**FINAL ADDENDUM
TO THE DRAFT EIR**

**OAKLAND CITY
ADMINISTRATION BUILDING
Environmental Impact Report**

February 1995

ER No. 92-7

Figure F-1
Area Affected by Downtown Incentives Package

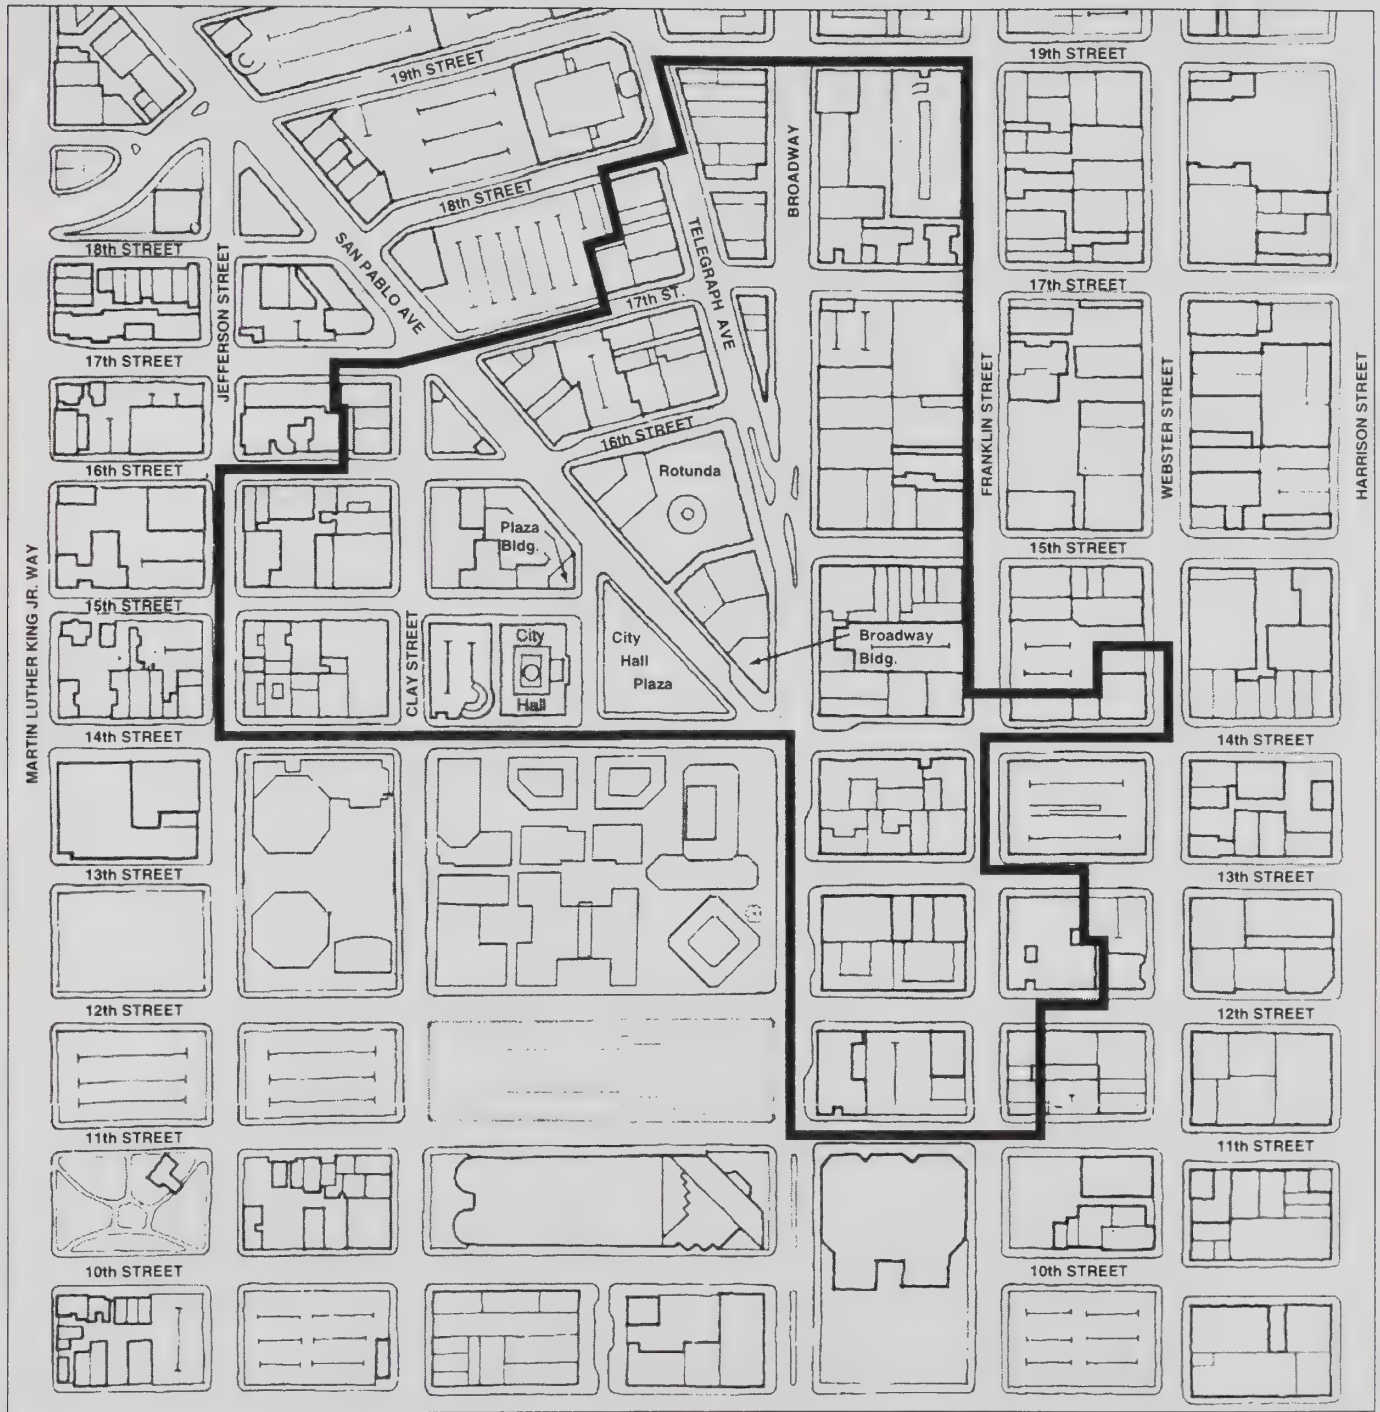
HIST-5d: To enhance the remainder of the Downtown District, the City shall adopt an Incentives Package prior to approval of the City Administration Building project.

Figure 10 (Revised)
Buildings on the
Alternative Project Site Blocks

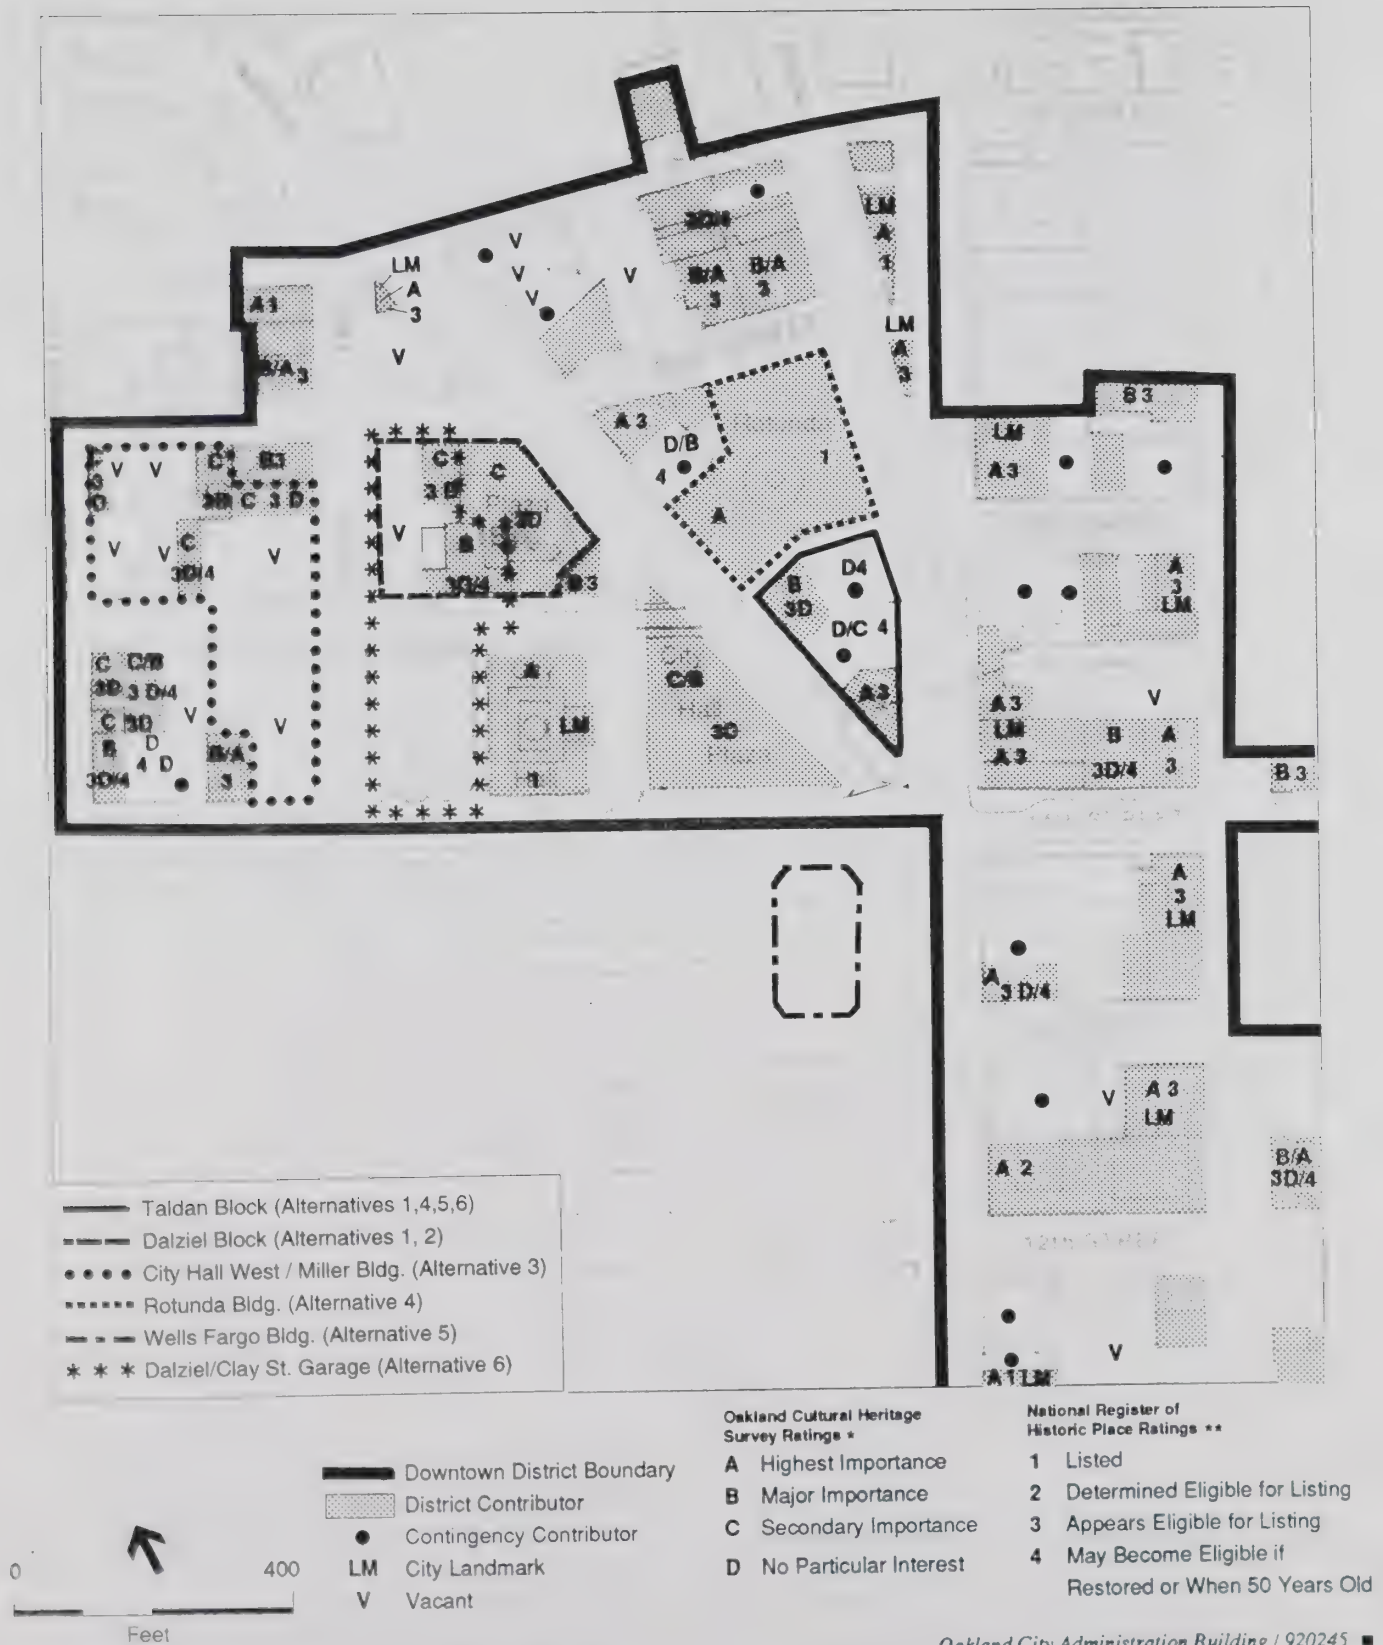
Page 99, Figure 10 is revised to indicate that the Plaza Building is not within the project area. (Revised figures appear at the end of Chapter II of this Final EIR Addendum.) [J-13m]

12. Figure 8 doesn't show any "land use designation" for the Plaza Building. 13L
13. Figures 10 and 11 mistakenly include the Plaza Building within the project site for Alternatives 1 and 2. 13M

- 13m) The commenter is correct in noting that the Plaza Building is not included in Alternatives 1 and 2, as depicted in Figures 10 and 11 of the Draft EIR/EIS. Please see Chapter II.B, Addenda to the Draft EIR/EIS, for revised Figures 10 and 11 of the Draft EIR/EIS.
